**Re: *Ex Parte* Presentation of the U.S. GPS Industry Council in
File No. SAT-MOD-20101118-00239 and IB Docket No. 11-109**

ATTACHMENT A

Executive Summary

Figure 1. LightSquared’s “Option 2” Proposal of Maximum EIRP as a Function of Base Station Antenna Height.

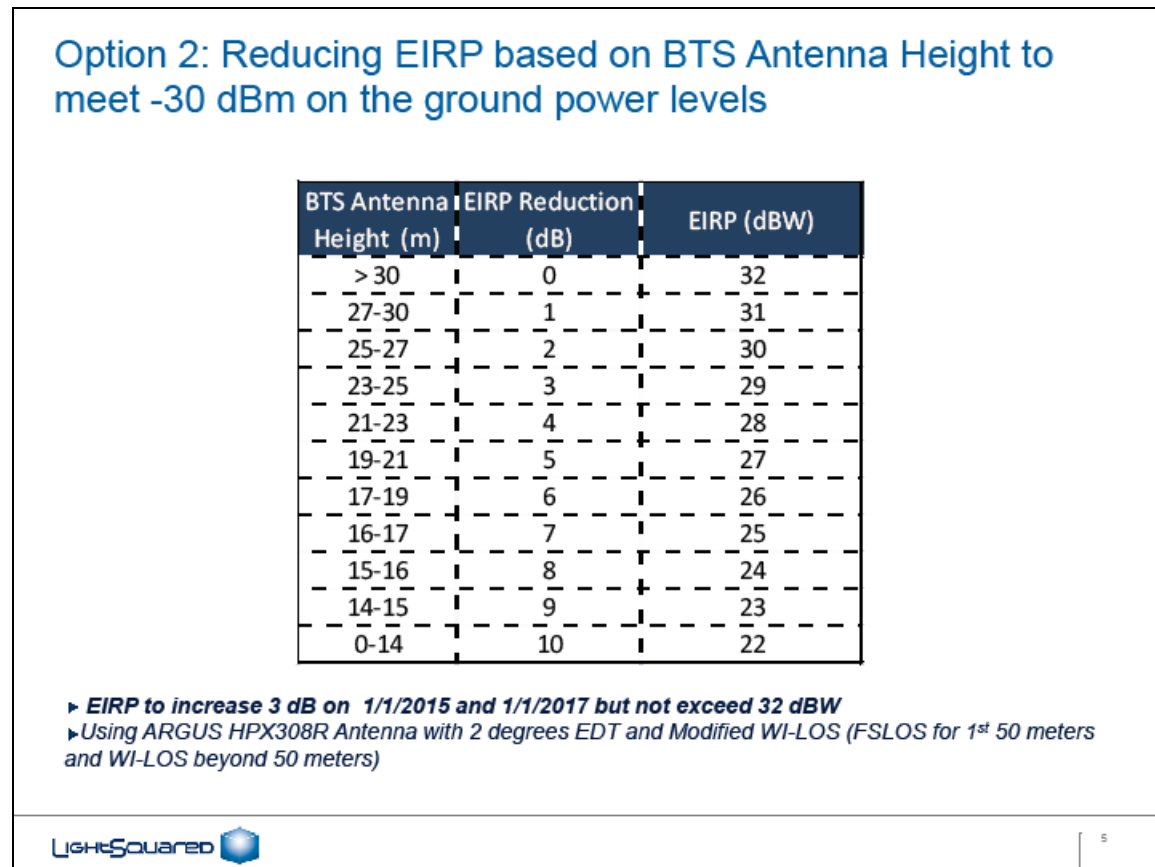
In attachment D of its October 6, 2011 ex parte report, LightSquared introduced a “power on the ground” proposal with a variation that it identified as “Option 2.” Rather than measuring interference power on the ground and restricting it to specified levels, Option 2 would set limits on the maximum EIRP that could be transmitted from a base station depending on the base station antenna height. LightSquared’s specific parameters for this proposal are set forth in Figure 1.

LightSquared’s Option 2 proposal is a completely unsuitable solution. Significant problems with this proposal include:

- The power on the ground that results from LightSquared’s proposed transmit powers still creates harmful interference when the proposal is analyzed using an appropriate propagation model suitable for interference analysis.
- The LightSquared interference power on the ground is significantly affected by the transmit antenna pattern. LightSquared seems to vacillate between two different transmitter antennas, each with its own unique pattern. Using either antenna, however, LightSquared’s operations will provide a maximum power on the ground in excess of -30 dBm, the level to which

Figure 2. LightSquared Interference Power on the Ground vs Distance Using a Free Space Propagation Model, Argus HPX308R Antenna, 32 dBm EIRP.

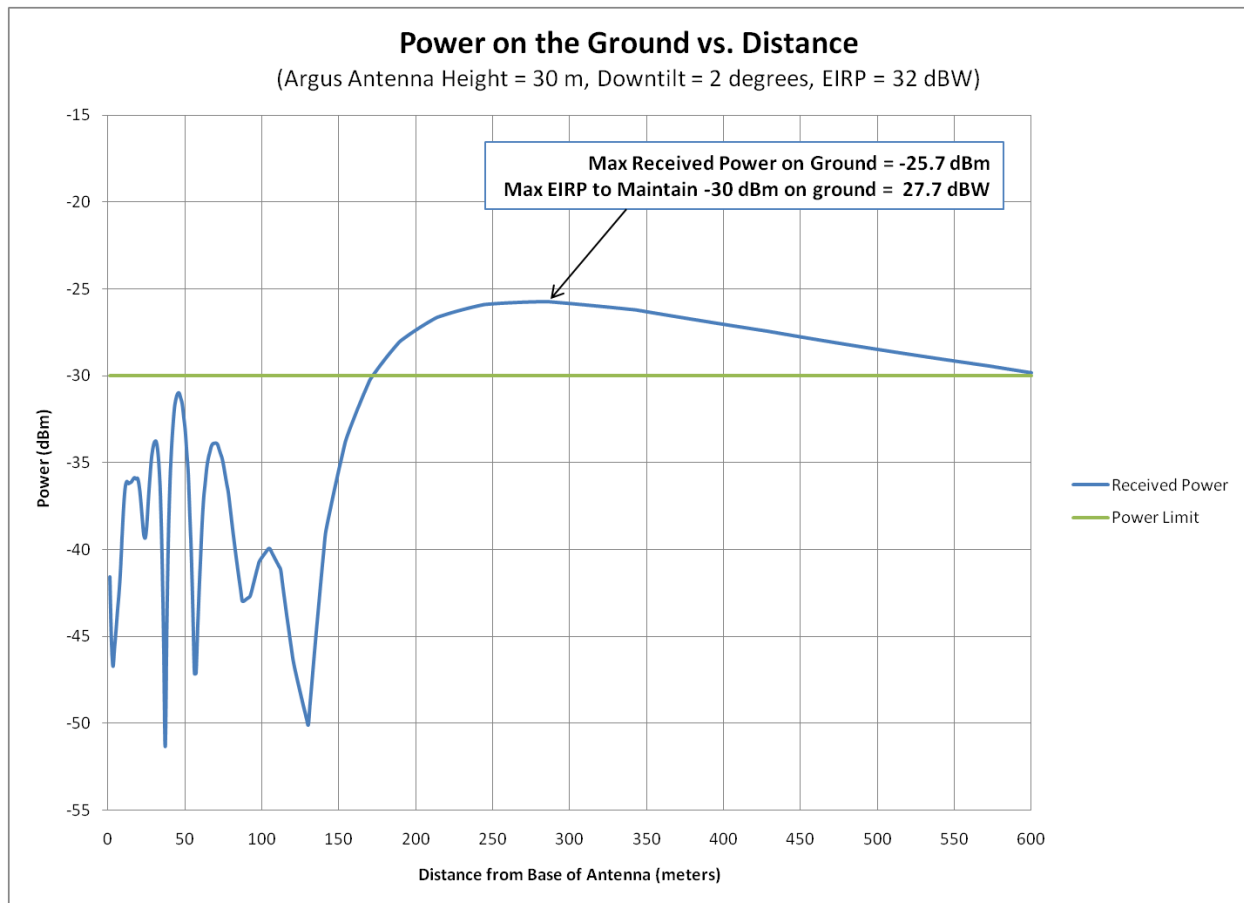
As can be seen, the power on the ground exceeds LightSquared's proposed -30 dBm limit by up to 4.3 dB at distances from 175m to 600m from the base station. In order to actually provide LightSquared's -30 dBm power limit, the base station EIRP must be reduced by 4.3 dB to 27.7 dBW from LightSquared's proposed 32 dBW.

Figure 4. Antenna Gain Pattern of Tongyu TDJ-151717DE Transmit Antenna

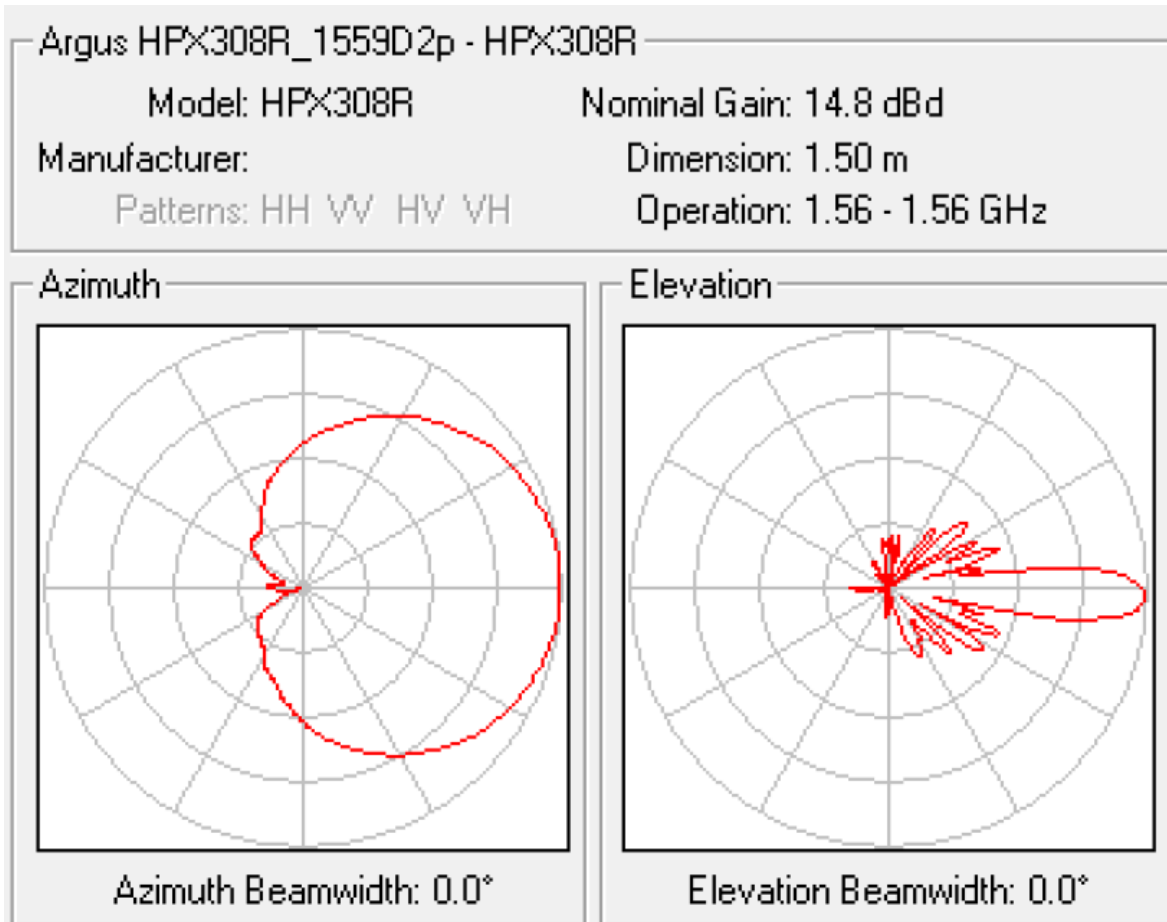
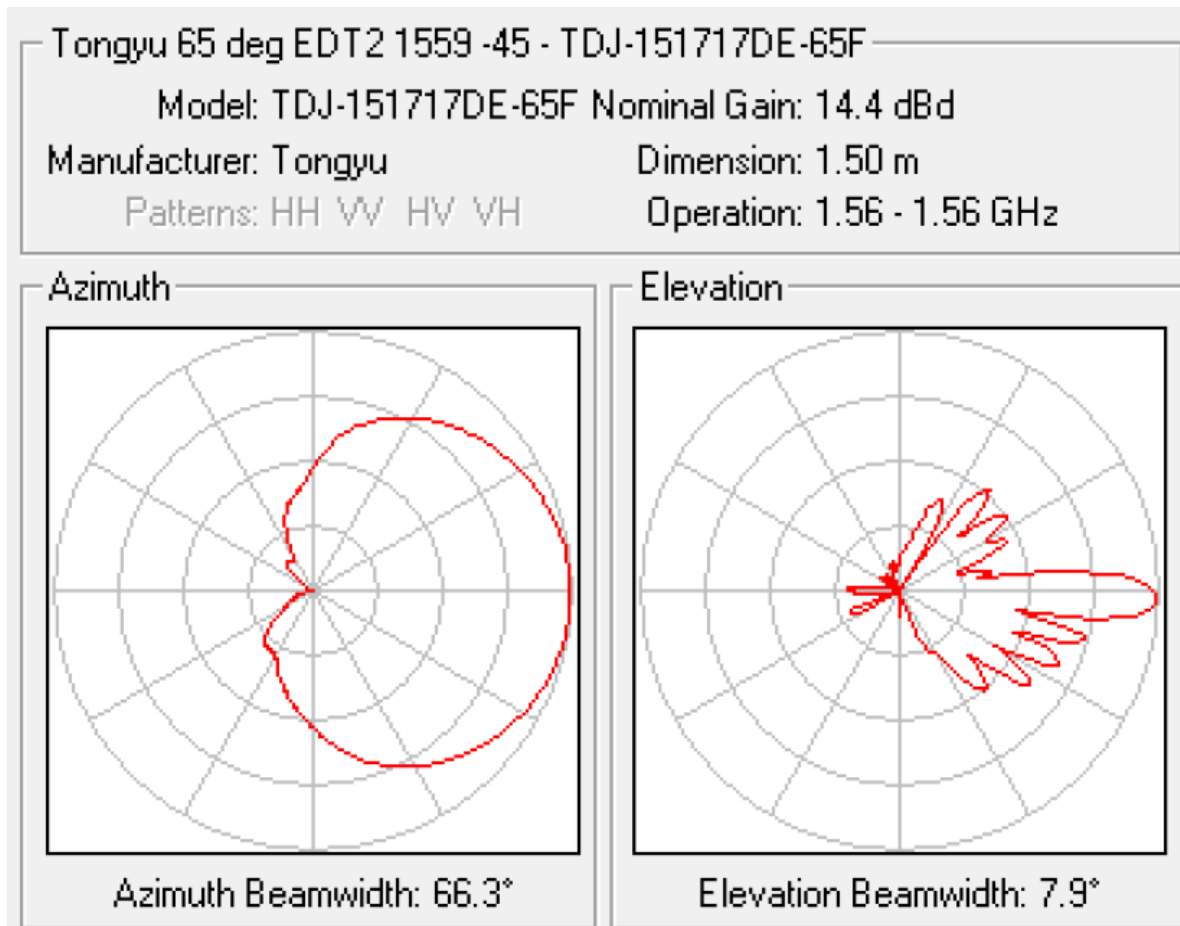
Analysis of received power on the ground is very dependent on an antenna's vertical gain pattern because as a receiver moves close to the foot of the base station antenna, it moves out of the main beam of the antenna. Two different base station antennas have been proposed by LightSquared – the Argus HPX308R that is assumed above, and the Tongyu TDJ-151717DE antenna that was assumed in the analysis performed by many sub-teams in the Technical Working Group. The vertical gain patterns for the two antennas are quite different underneath the main beam. The elevation plots for the two antennas provided below illustrate this.

The Tongyu antenna radiates noticeably more power below the main antenna lobe than the Argus antenna.² This means that if a Tongyu antenna were used in a base station installation, far greater interference power would be experienced on the ground near the tower than if an Argus antenna were used. It is far from clear whether LightSquared has ruled out the use of the Tongyu antenna, as it was extensively used in the Technical Working Group analysis.³ LightSquared also specified the use of the Tongyu antenna in RTCA SC-159 analysis.⁴

Figure 5. Power on the Ground vs. Distance for Tongyu (Red) and Argus (Blue) Transmit Antennas

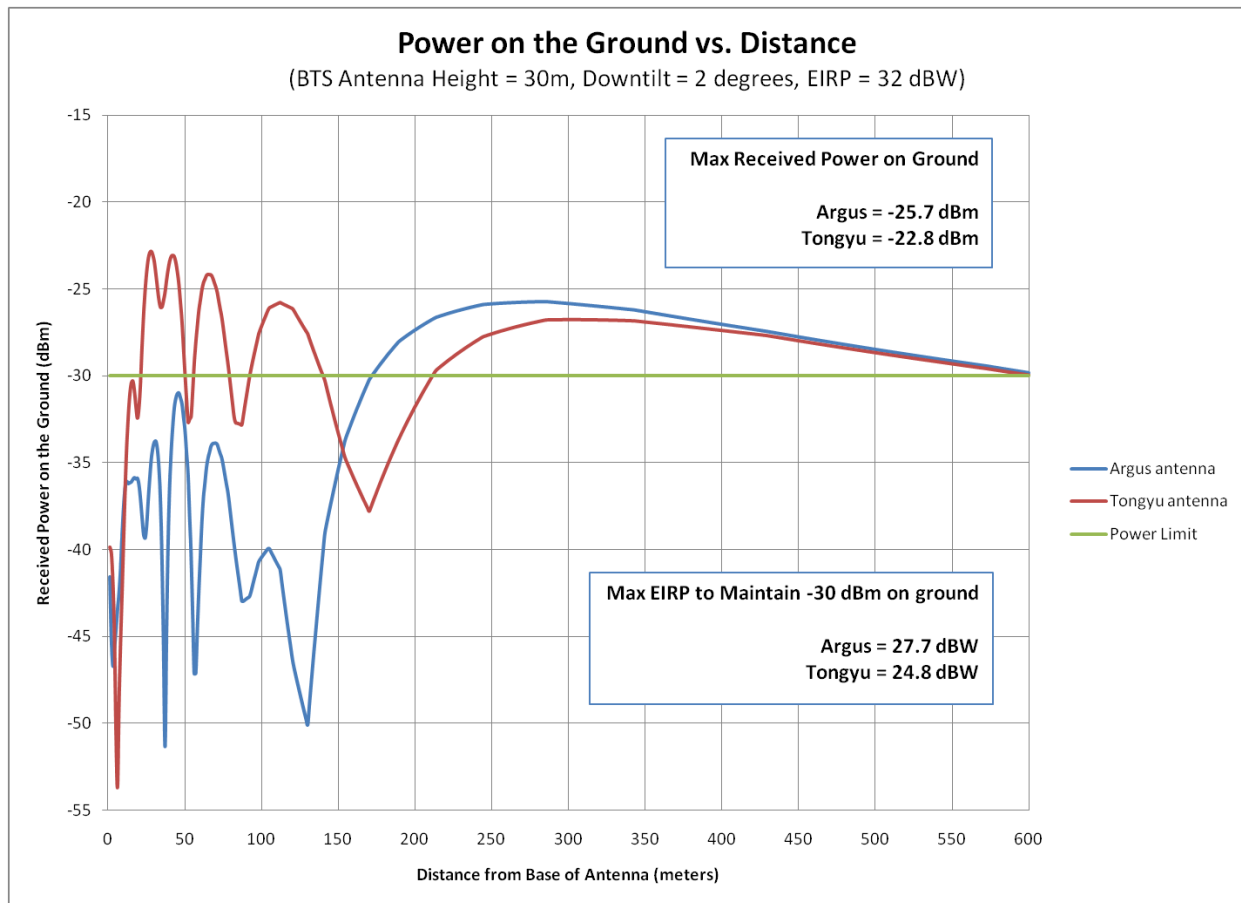
Figure 5 illustrates this fact. Note that the maximum power on the ground when using a Tongyu antenna is -22.8 dBm, more than 7 dB above LightSquared's -30 dBm limit. With the Tongyu antenna, the maximum power on the ground occurs close to the base of the tower, even though the receiver would be out of the main beam of the antenna. Further, the peak power on the ground from the Tongyu

antenna is almost 3 dB higher than what would be seen with the Argus antenna. There are two important points illustrated by this plot:

1. The Argus and the Tongyu antennas, two antennas proposed by LightSquared as being used in their terrestrial deployment, will in fact provide power in excess of -30 dBm on the ground.
2. The choice of transmit antenna (and the transmit antenna gain) is a critical parameter for determining the power on the ground. LightSquared's proposal to reduce EIRP based on antenna height is not credible unless it accounts for the different gain patterns of the antennas that will be deployed as part of LightSquared's network.

Figure 8. Effect of Receiver Height on Received Power, Transmit Antenna 30 m, Receiver Antenna 15 m.

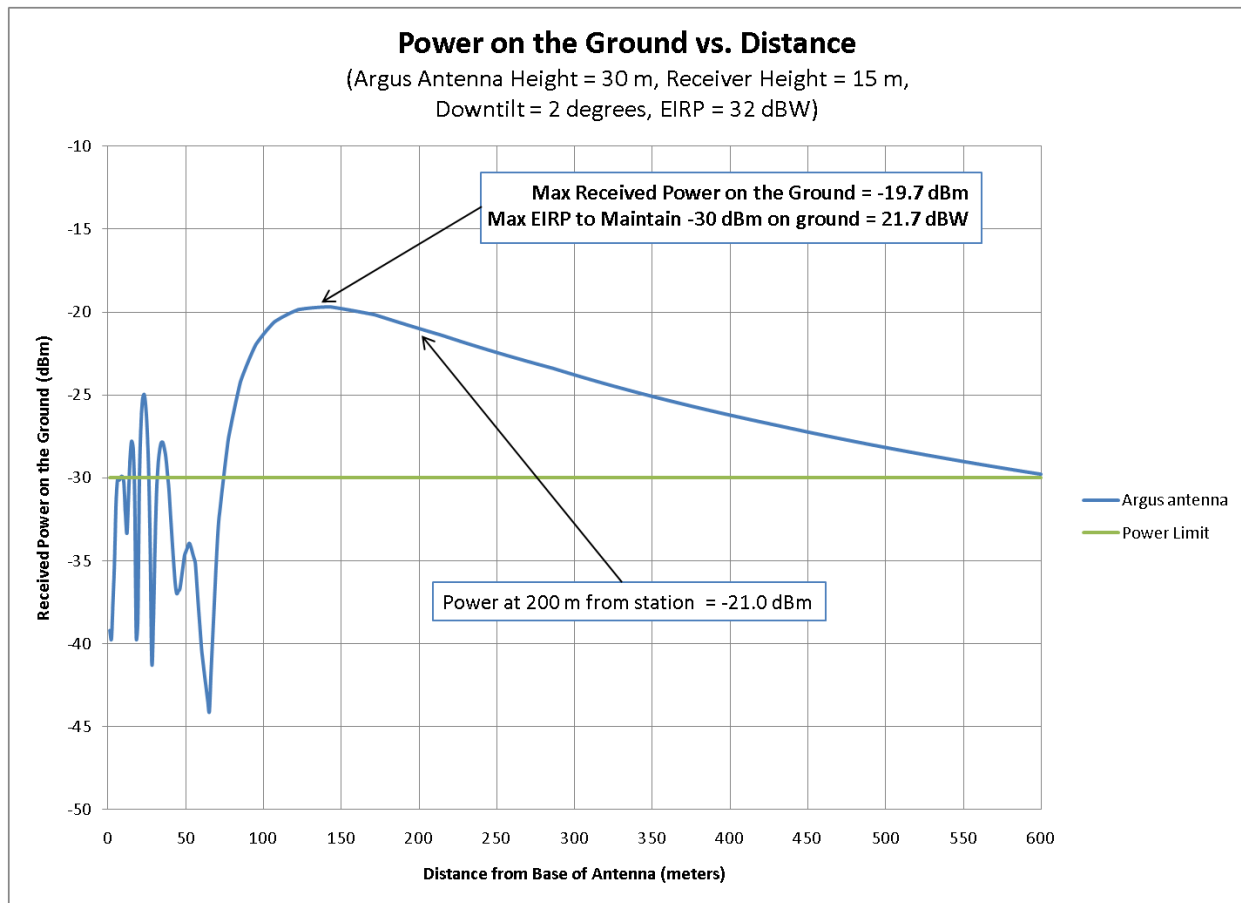
Assume as an example that the receiver is 200 meters from a LightSquared base station on an elevated freeway approximately 15 meters (50 feet) above the ground. The LightSquared base station has an antenna height of 30 meters. In this case, the base station antenna is only 15 meters above the receiver. As the chart below indicates, the receiver would see a power level of -21 dBm at a distance of 200 meters from the base station.

This chart shows a power level 9 dB, or eight times greater than the -30 dBm level proposed by LightSquared. It clearly demonstrates that variation in receiver height must be properly accounted for in an interference mitigation proposal, which is not the case in LightSquared's proposal.

Figure 9. Power on the Ground as a Function of Antenna Downtilt, Argus Antenna

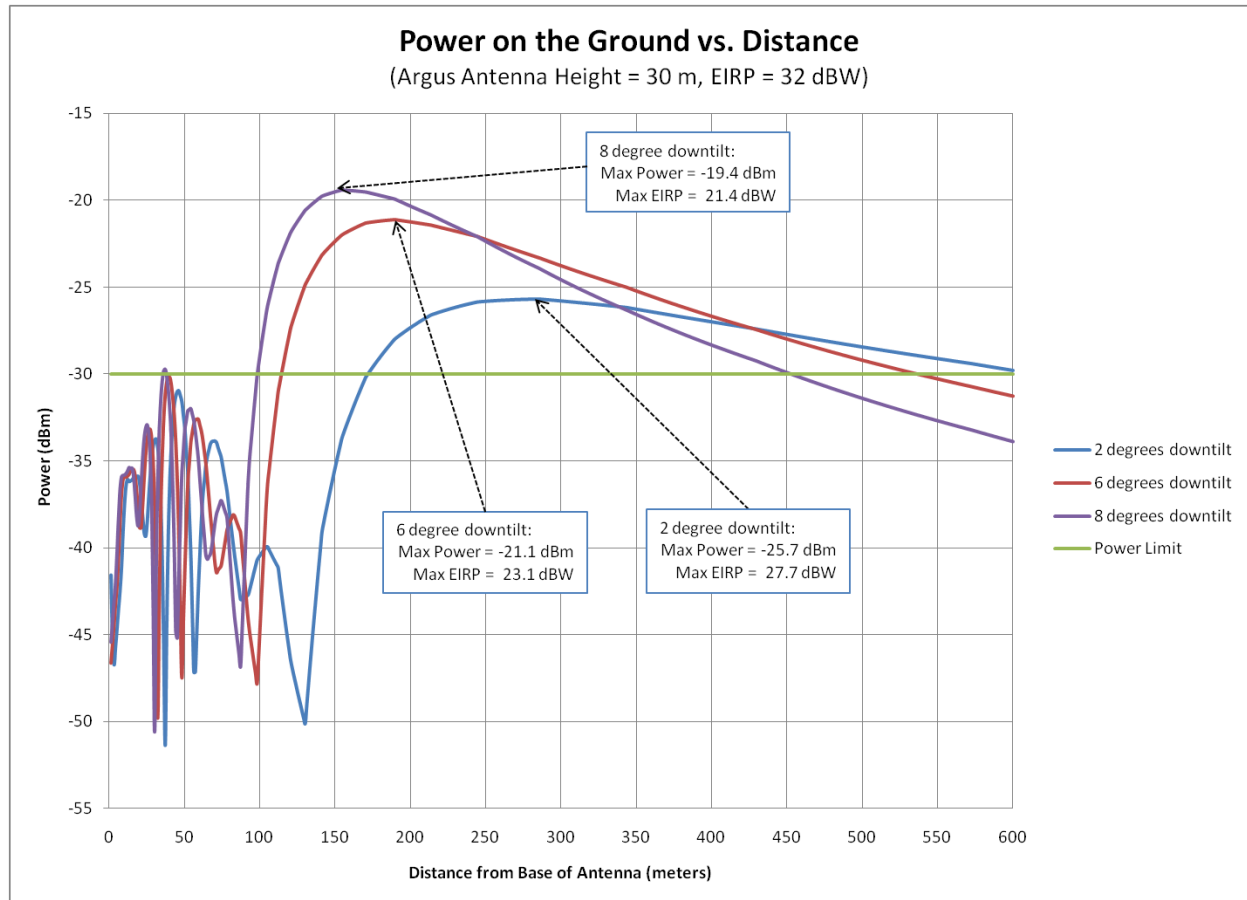
As can be seen from the plot above, merely increasing the antenna downtilt by four degrees raises the maximum power observed on the ground to -21.1 dBm, which is almost 9 dB (almost 8 times) higher than the -30 dBm limit proposed by LightSquared. It is also 4.6 dB higher than the power levels expected with a two degree downtilt – almost tripling the peak power on the ground. Downtilting the base station antenna by 8 degrees increases the maximum power on the ground to -19.4 dBm.
